E8364CH85-02A

S E R V I C E N O T E

E8364CH85 PNA Microwave Network Analyzers

A new touchscreen display inverter shield is available to improve PNA noise floor performance.

Figure 3

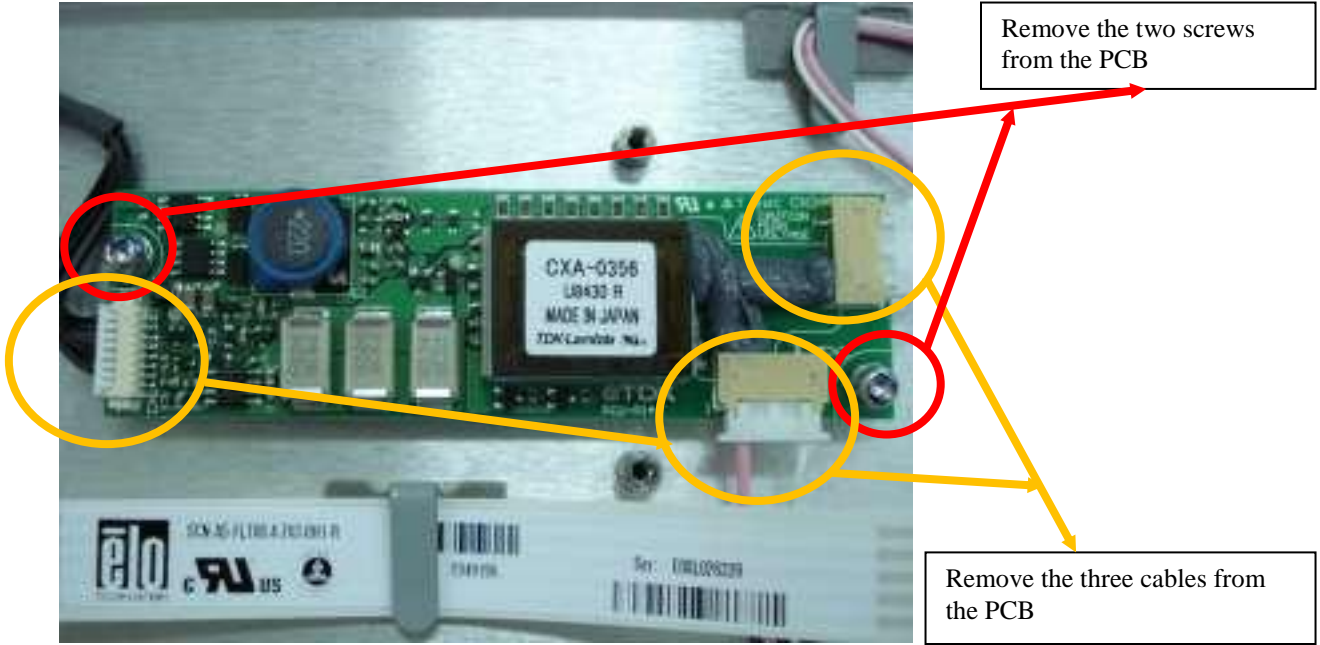
10. Remove the two screws from the PCB shown in Figure 3, using a T-10 wrench. Disconnect the three cables connected to the PCB.
